Determination 2013/068

The compliance of a timber barrier to a deck, with respect to Clause B1 Structure, to a house at 99 Blue Pacific Parade, Riversdale Beach, Masterton

Figure 1: Part section through deck and barrier (not to scale)

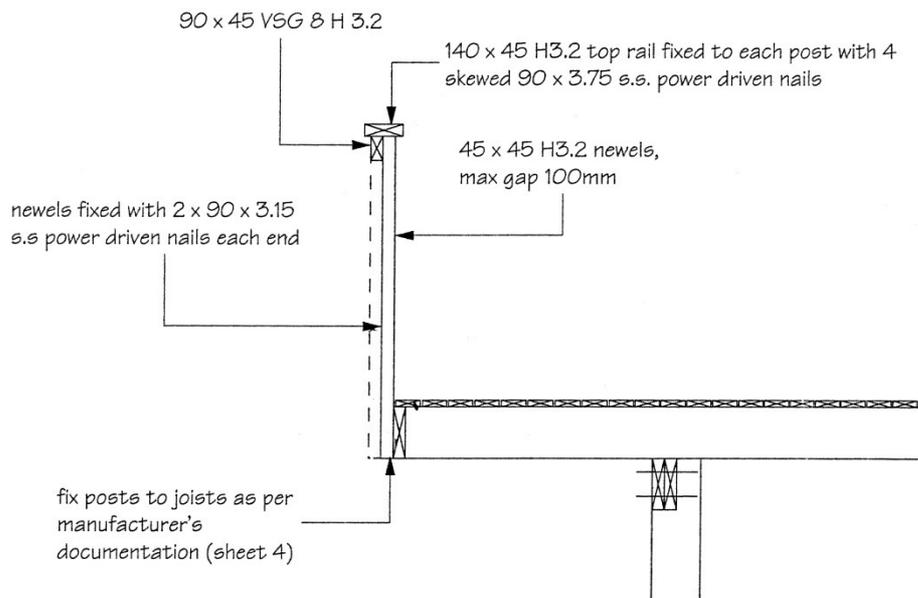
- 3.1 The designers applied for a building consent for the deck and barrier in March 2013.
- 3.2 In an email to the designers dated 19 March 2013, the authority requested additional information. As regards the deck barrier, the authority stated:

- Please specify the maximum gap between the bottom rail and deck floor
- Please indicate how the top rail, bottom rail and palings are to be fixed
- 3.3 The designers responded by email on 2 May 2013, and in respect of the barrier said:

- 3.4 The authority emailed the designers on 3 May 2013, noting that the barrier elevations did not align with those indicated by the designers. The authority also said that the designers need to demonstrate how the barrier fixings complied with Clause B1. It was suggested that the designers might like to refer to the published *Guidance on Barrier Design* document (“the guidance document”)⁵, or alternatively, provide another specific engineering design. The latter option ‘may need to be screened by a structural engineer’ engaged by the authority.

- 5.4 The experts concluded that the 45x45 newel post satisfied the strength requirements, but only when the newel post was fixed to the deck members in a manner where the newel developed some bending moment capacity to reduce the overall bending strength demand. The newel did not have sufficient strength when it was considered a simply-supported beam.

- 5.5 The experts' report provided detail of the nail size and position in order to achieve the necessary bending capacity. It is noted that the proposed design did not specify how the newel posts were to be fixed other than the size of the nails used.

- 5.6 The experts considered the proposed design did not satisfy the deflection requirements: when subject to design loading, the horizontal deflection at the top of the balustrade exceeded the limit given in AS/NZS 1170 by 5%.

- The newels are fixed to the deck framing as there is no bottom rail proposed ...
- ... refer updated section [on sheet 2] detailing the requirements to fix the framing with power driven s.s nails ...

- 6.1 I accept that the calculations shown in the experts' report confirm that provided the nailing requirements recommended by the experts are used, the 45 x 45mm newel posts comply with the Clause B1 in terms of strength. The nailing required to achieve this was not detailed in the proposed design and consequently there was insufficient evidence to show that barrier with comply with Clause B1 Structure

- 6.2 The experts' calculations indicate that the barrier does not meet the requirements of AS/NZS 1170 in respect of deflection: the deflection limit is exceeded by only a small margin (5%). The deflection limits given in AS/NZS 1170 are provided in an informative section of that standard.

- 6.3 The Building Code Clause B1.3.2 says that buildings and building elements 'shall have a low probability of causing loss of amenity through undue deformation ...' Given the deck's expected use I do not consider there will be any significant loss of amenity arising from the expected deflection.

- 7.1 In accordance with section 188 of the Building Act 2004, I hereby determine that there is insufficient evidence to show that the deck barrier as proposed will comply with New Zealand Building Code Clause B1 Structure.
